TO: Mountain Village Design Review Board
FROM: Amy Ward, Planner
FOR: Design Review Board Public Hearing; May 6, 2021
DATE: April 26, 2021
RE: Staff Memo – Initial Architecture and Site Review (IASR) Lot 628-H, 116 Double Eagle Way

APPLICATION OVERVIEW: New Single-Family Home on Lot 628-H

Site
Grading
with
Driveway
Profile

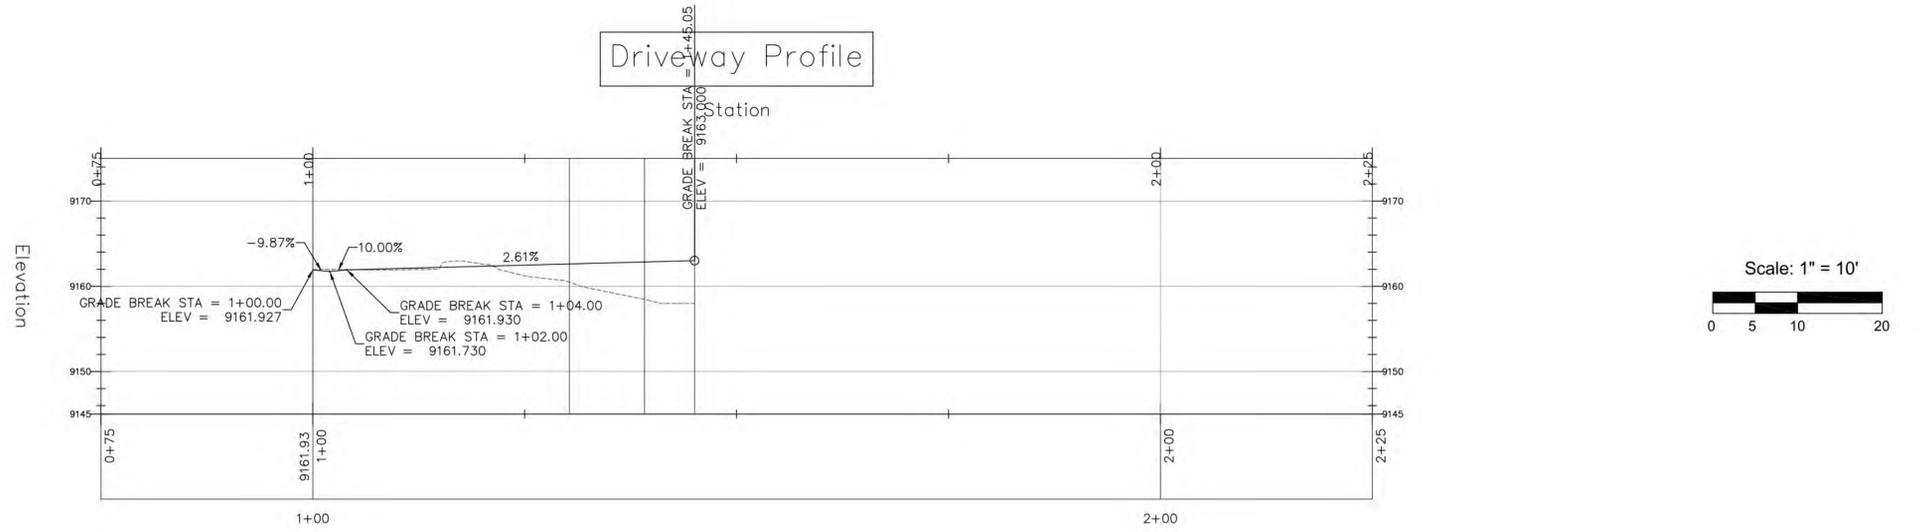
Staff: The applicant has proposed minimal grading/site disturbance and there appears to be positive drainage away from the home. The applicant has not included finished slopes on the grading plan, these should be added prior to final so that we can assure compliance with CDC regulations. In addition, there is an existing mulch path on the SE corner of the lot that will likely be damaged during construction, staff recommends that the applicant plan to restore this path to pre-construction conditions.

Staff: The driveway grade is 2.6% which meets the grade requirements of the CDC. There is a notation of a small area of 10% grade, staff believes this is probably just the slope of the v-pan, but will ask that this is clarified by the applicant. The driveway width appears to be 19', though this dimensions should be called out on the plan. As drawn, the applicant is proposing the two exterior parking spots in the hammerhead of the drive (as previously discussed in this memo, the location within the GE and/or road right of way needs to be clarified). With cars parked in this area, the drive no longer has a path for turn around when backing out of the garage. If DRB finds this parking layout approvable, then they would need to allow a design variation to the road and driveway standards for the lack of back out space.

- 7) Prior to final review, the applicant shall provide finish slopes on the grading plan.
- 8) Prior to final review, the applicant shall revise exterior materials to replace areas of wood siding where it meets the grade with a more durable material option.

Utility
Plan

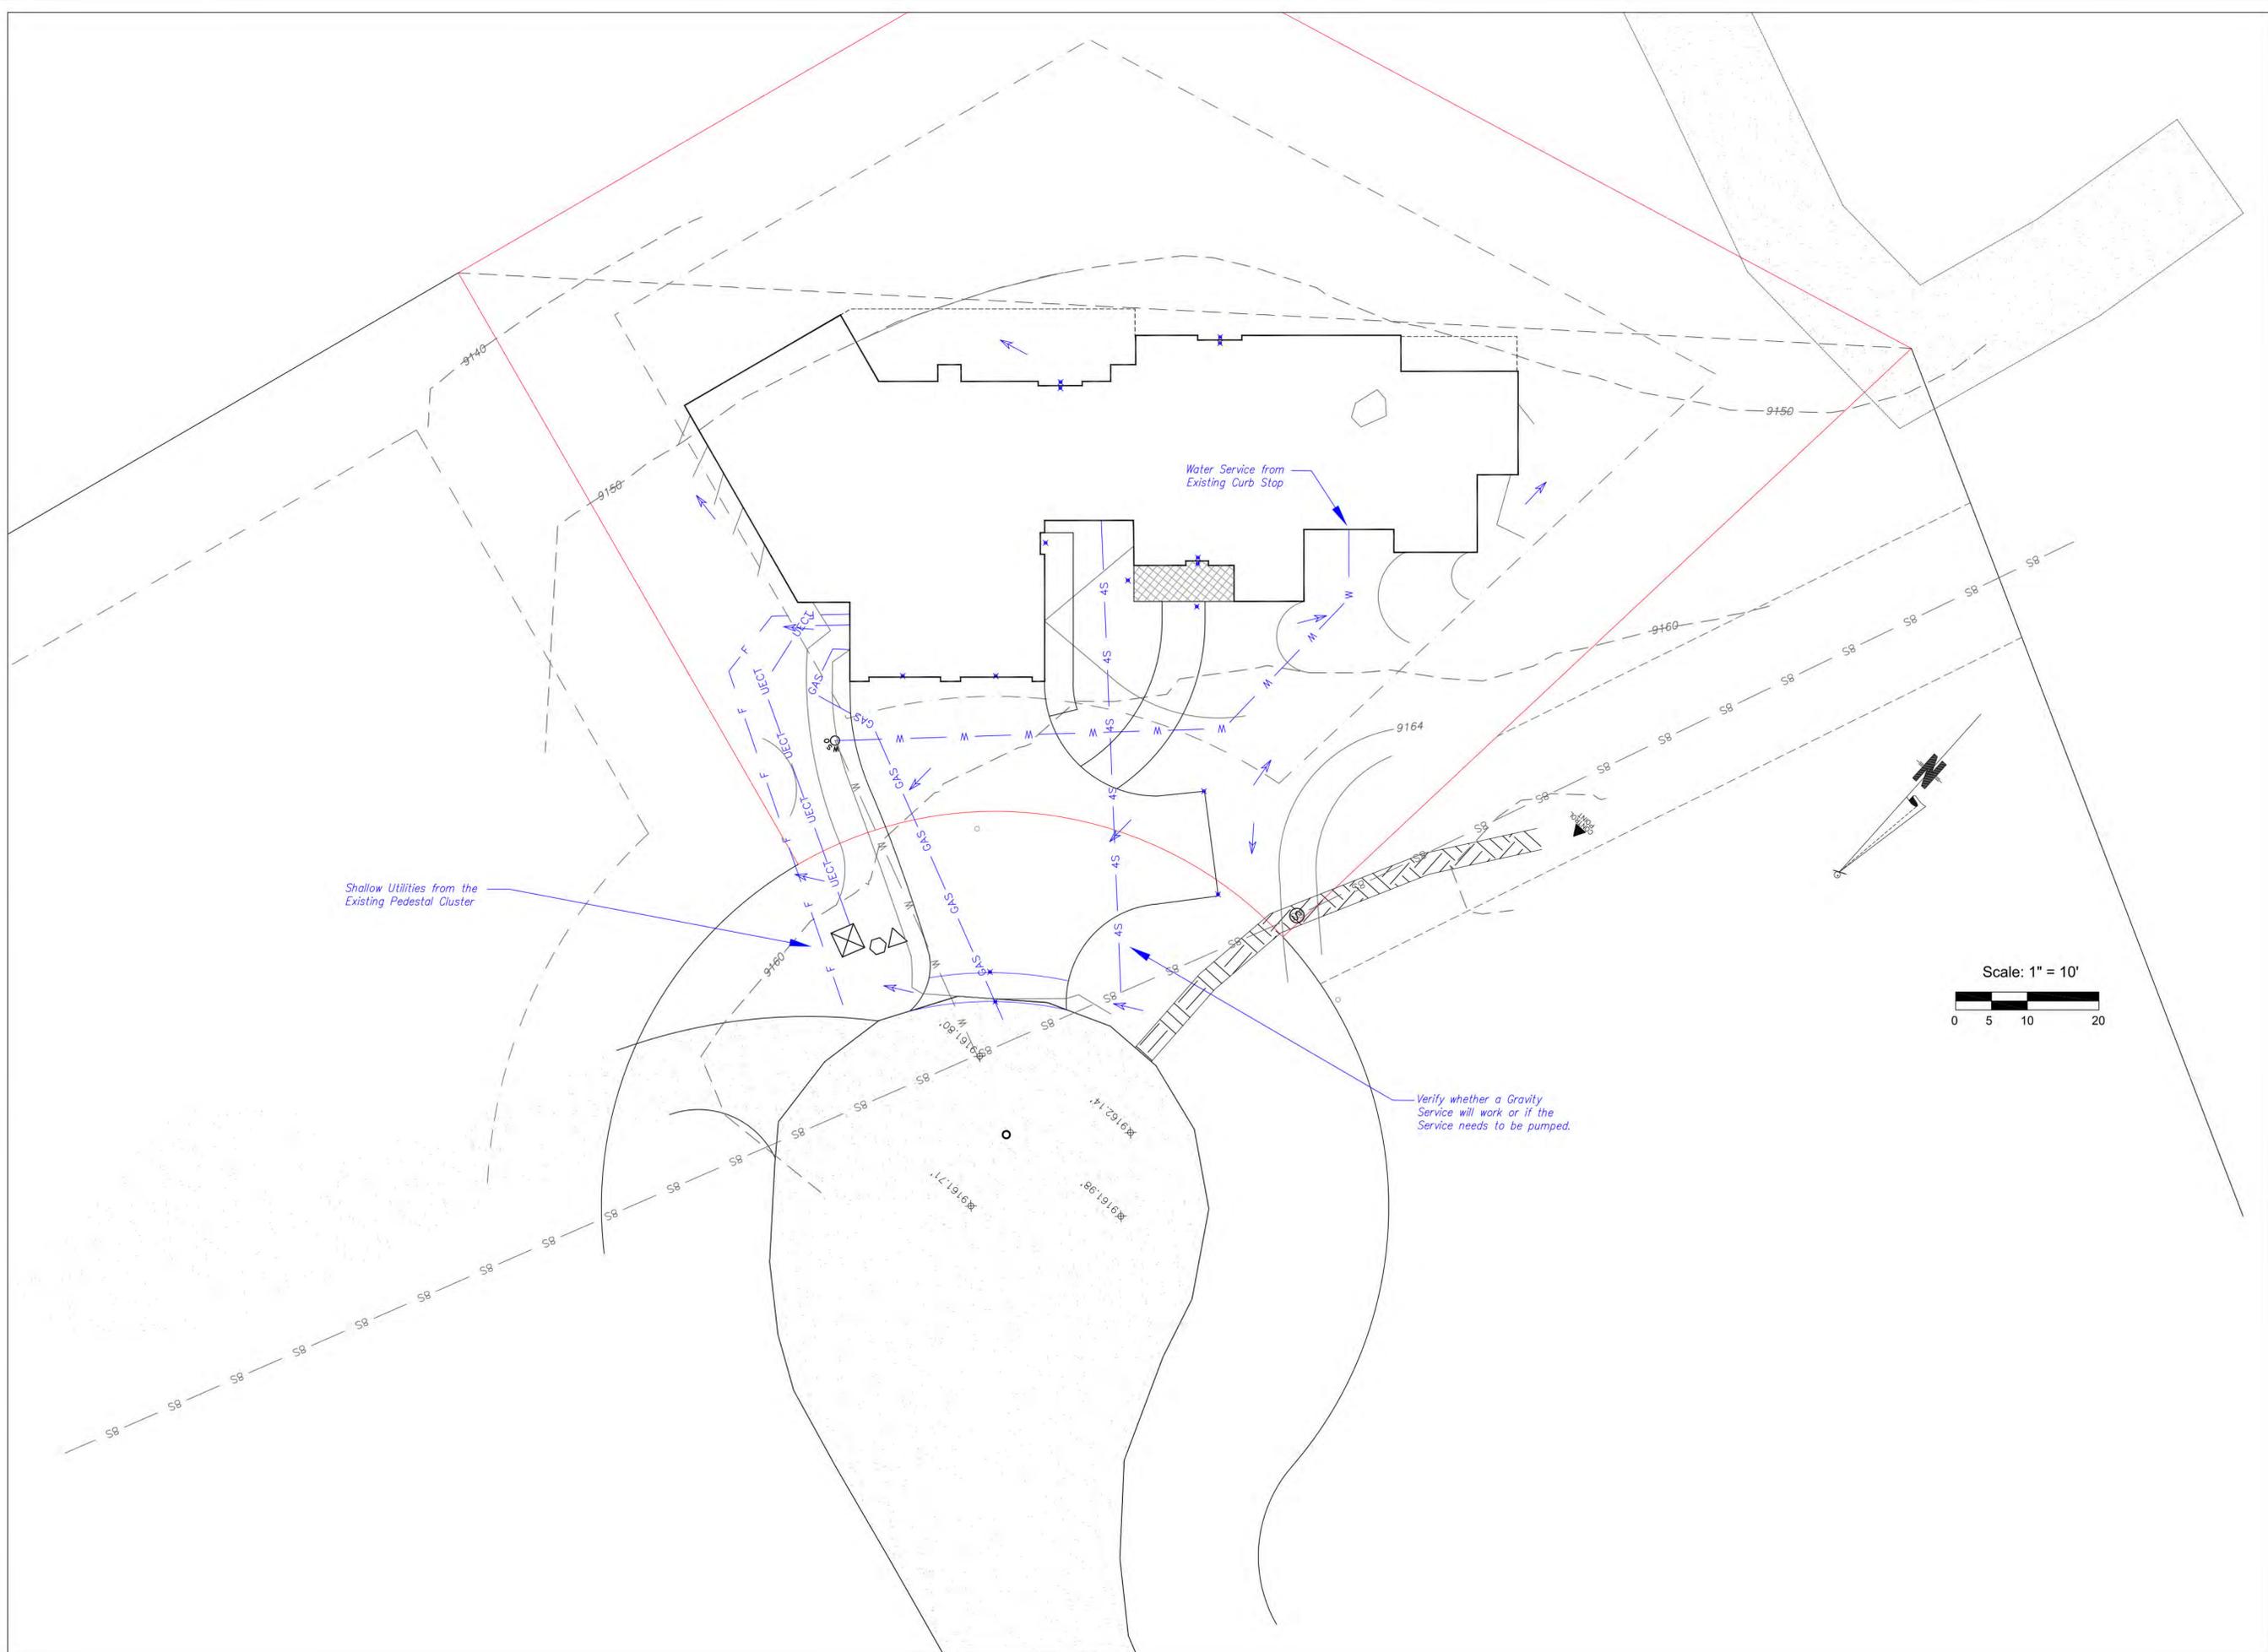
Staff: The civil plans do show utility connections and prior to issuance of a building permit, the applicant shall work with the Public Works Director and all other utilities to verify all locations for connections.

- 9) Prior to the issuance of a building permit, the applicant shall field verify all utilities and submit a revised utility plan to the public works director identifying the location of utilities and connection points.

A0.1
SITE PLAN

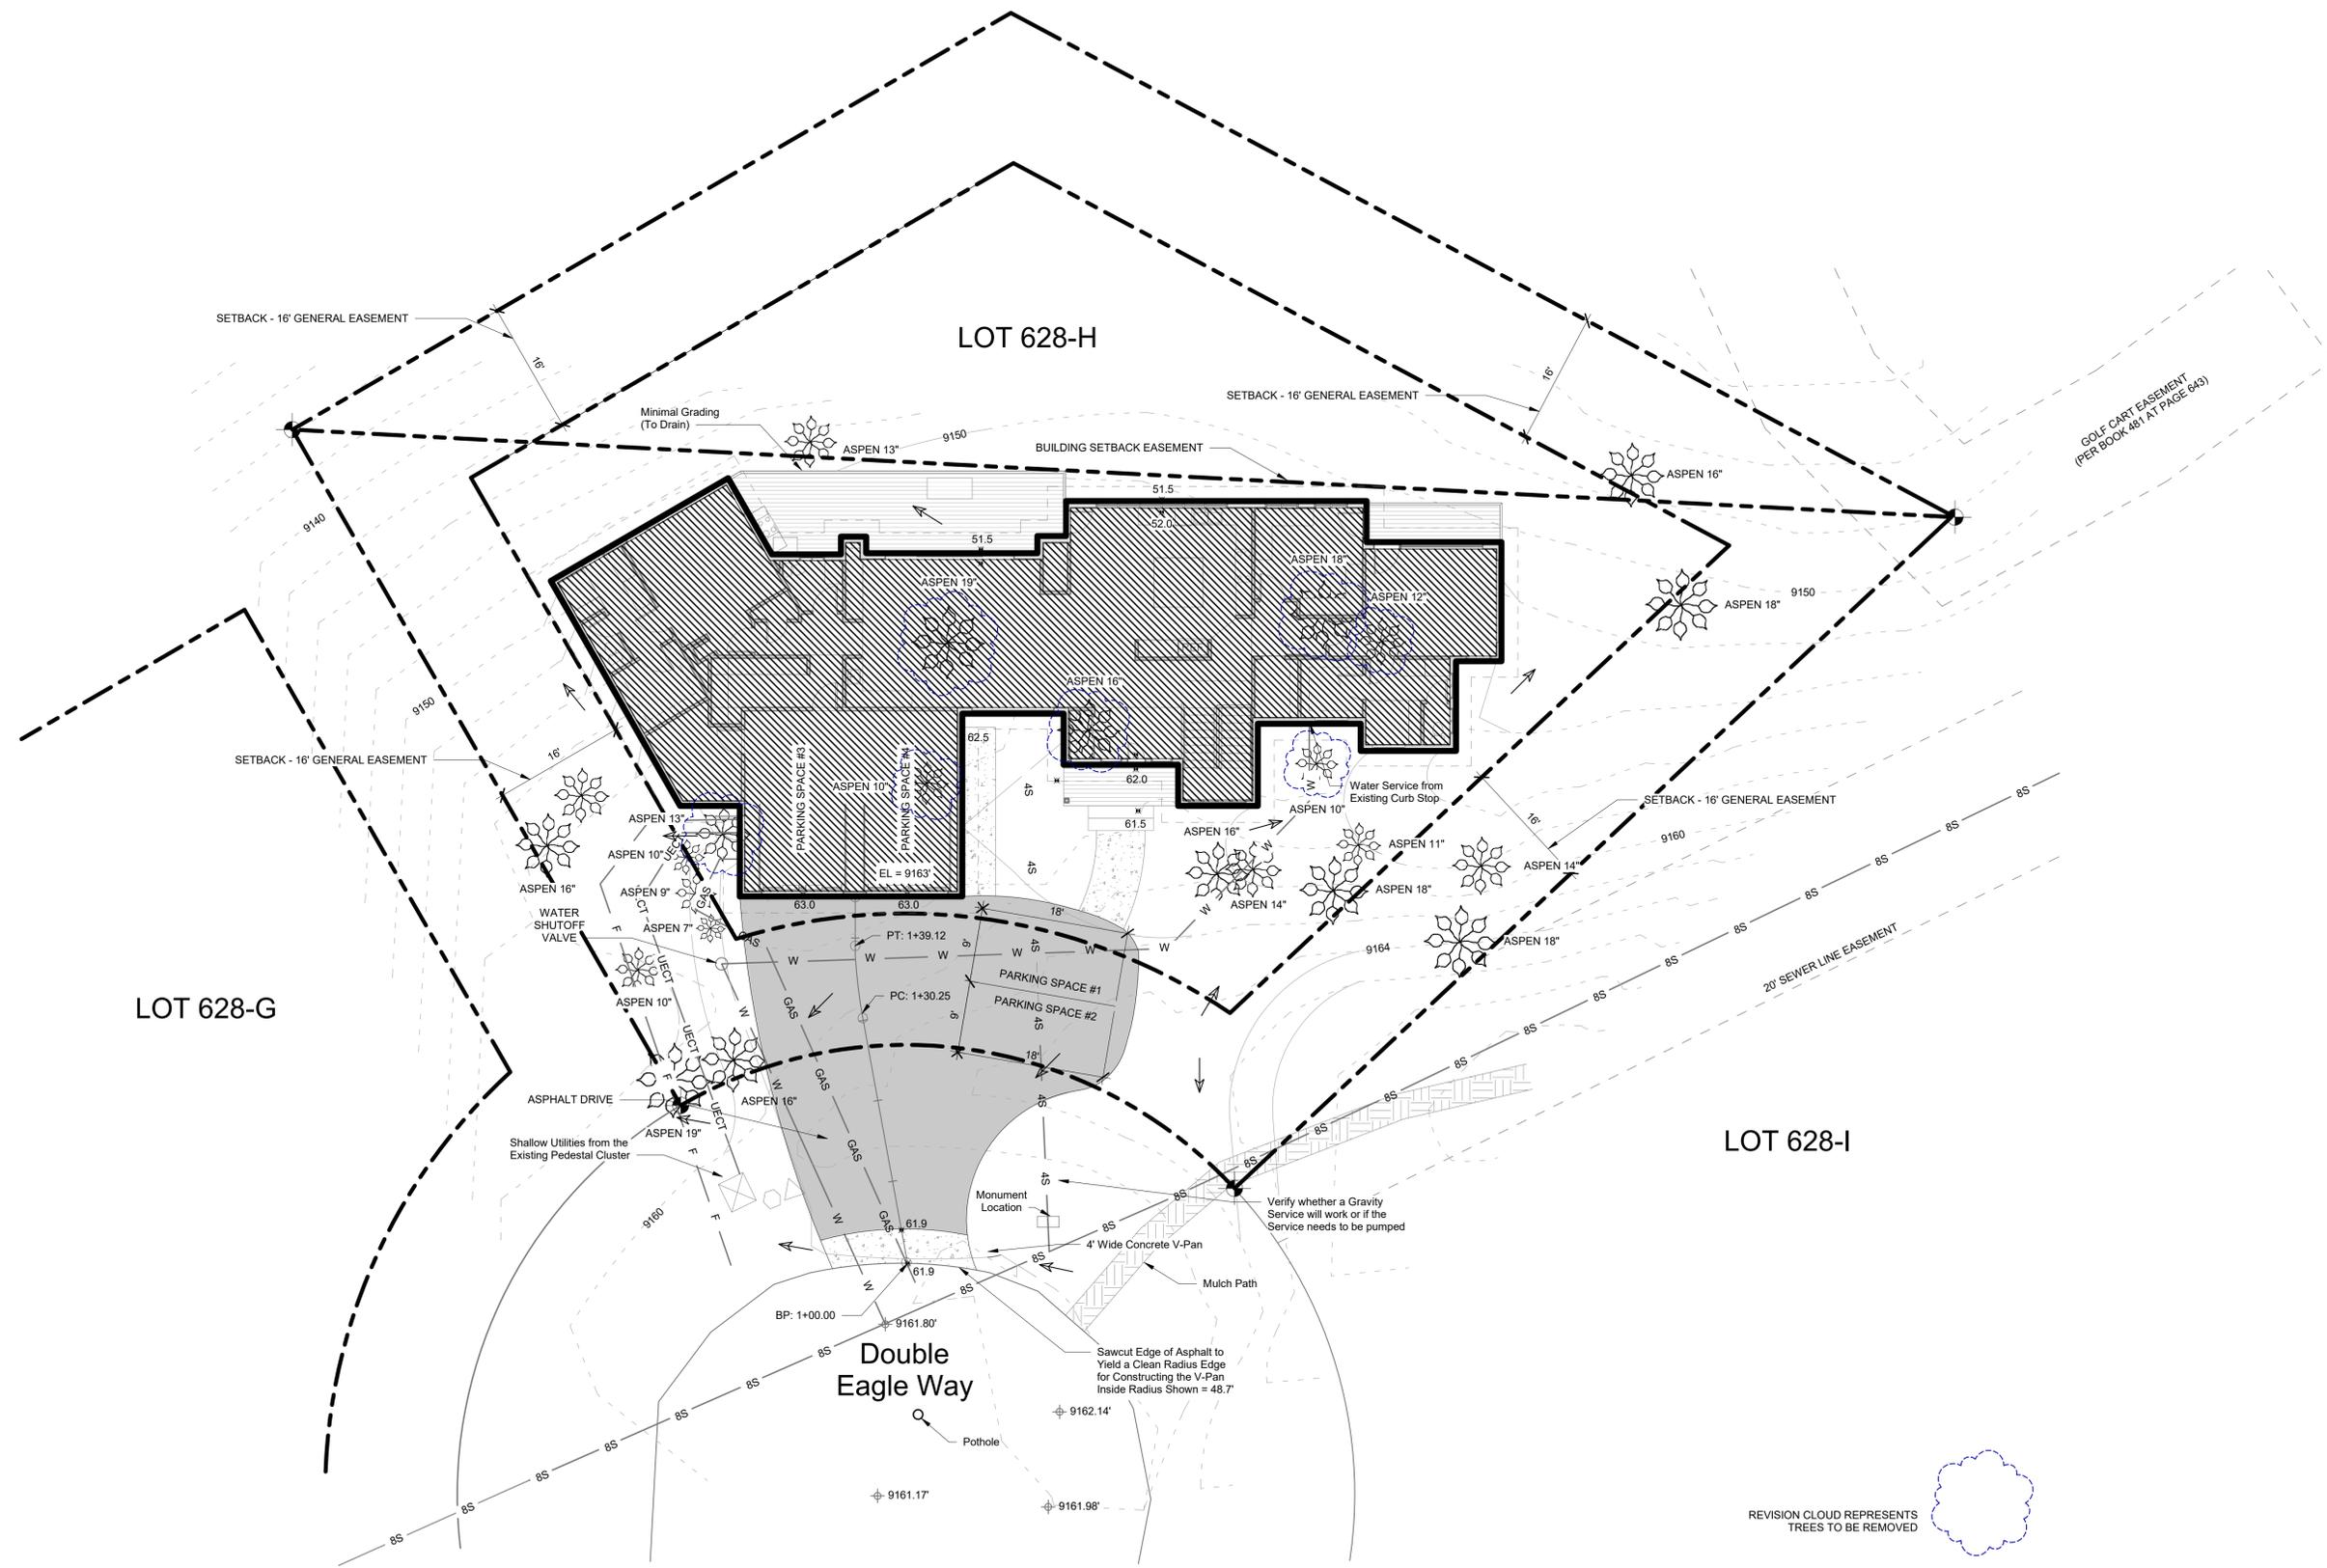
Staff is generally comfortable with the approval of parking in the GE due to the constraints of the lot, however it should be noted that the civil drawings show the proposed parking as overlapping the GE and the road right of way. In no instance is parking in the road right of way allowed per the CDC so regardless of whether DRB grants approval of the GE encroachment, the parking needs to be re-designed prior to final to remove any portion of parking from the road right of way.

Staff: The CDC requires all single-family homes to provide two interior and two exterior parking spaces. The applicant has shown two interior spaces and two exterior spaces. Currently, the exterior parking is shown mostly within the GE on the site plan, however, in the civil drawings it is shown half in the GE and half in the road right of way. The CDC expressly prohibits any parking in the road right of way. The applicant will need to coordinate his drawings so that the site plan and civil drawings are in agreement and bring the parking outside of the road right of way at a bare minimum. If the parking is provided as shown on the site plan within the GE, DRB would still need to grant specific approval for the GE encroachment.

- 2) Prior to final review, the applicant shall revise the parking to remove it entirely from the road right of way and assure consistency between the civil drawings and the site plan.

A1.1
ROOF PLAN

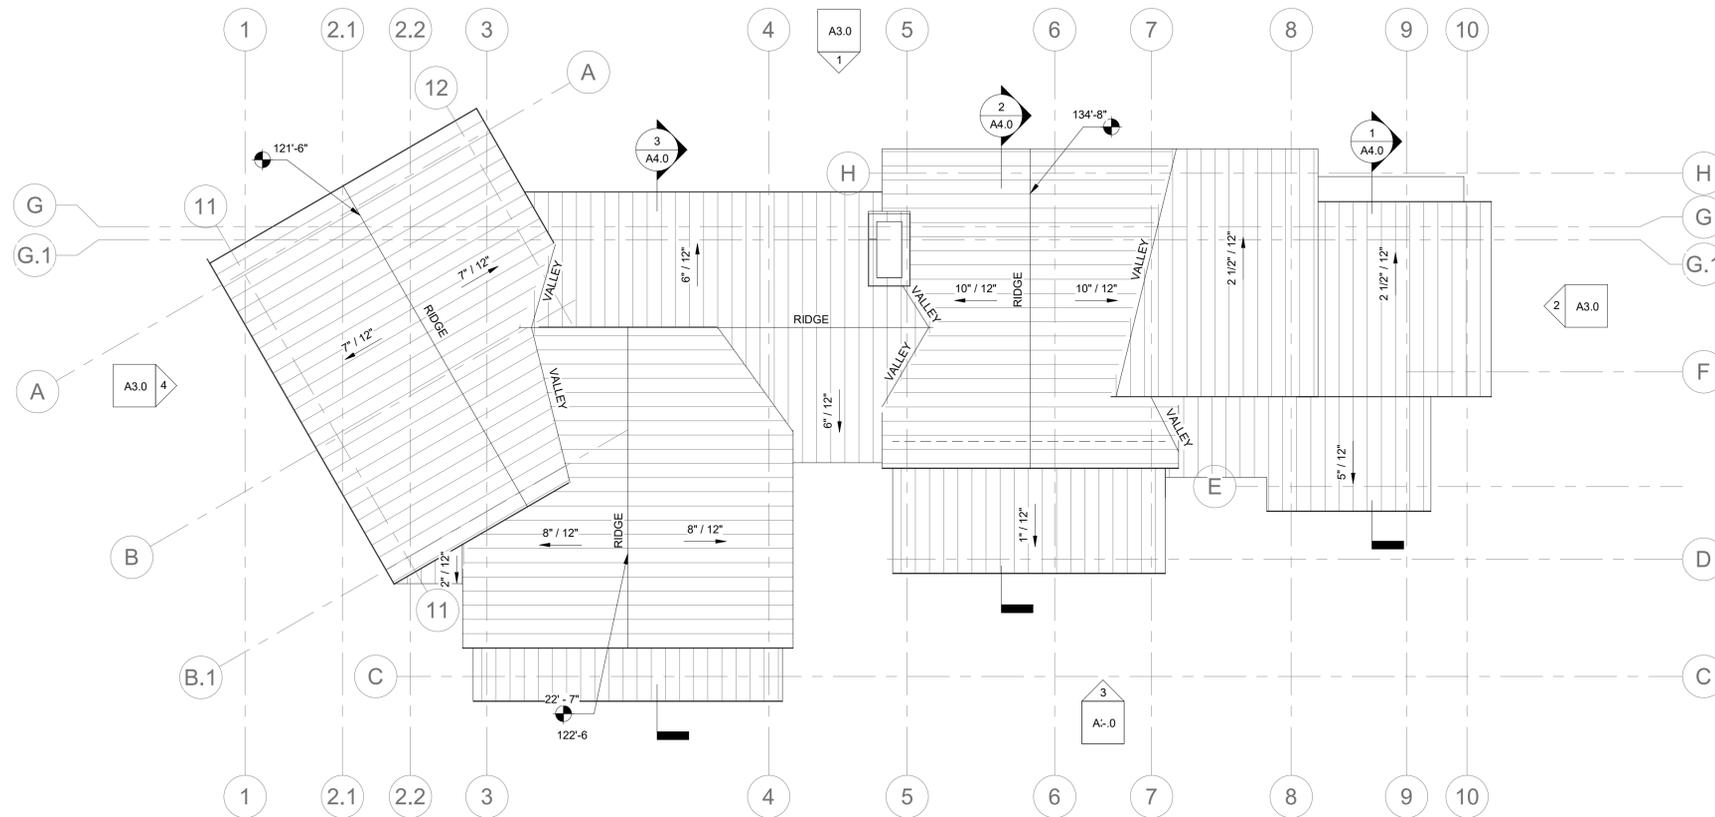
Window and door trim are proposed as black-clad windows, and a full window and door schedule has been provided. The appropriate recess of doors and windows in areas with stone veneer has been noted on the plans, however, the applicant has not provided a detail of the recess at the garage doors and this should be done prior to final. The proposed roofing material is a dark gray standing seam product, and the fascia of the home is rough cedar. The CDC allows for Black and Grey standing seam roofing materials and this appears to meet that requirement. It should be noted that the applicant has not shown snow fencing on the roof plan, and this should be added in areas where snowfall is a potential hazard..

- 5) Prior to final review, applicant shall revise the roof plan to include snow fencing.
- 6) Prior to final review the applicant shall revise the drawings to clearly demonstrate average height compliance and provide a parallel plane analysis to further illustrate height compliance.
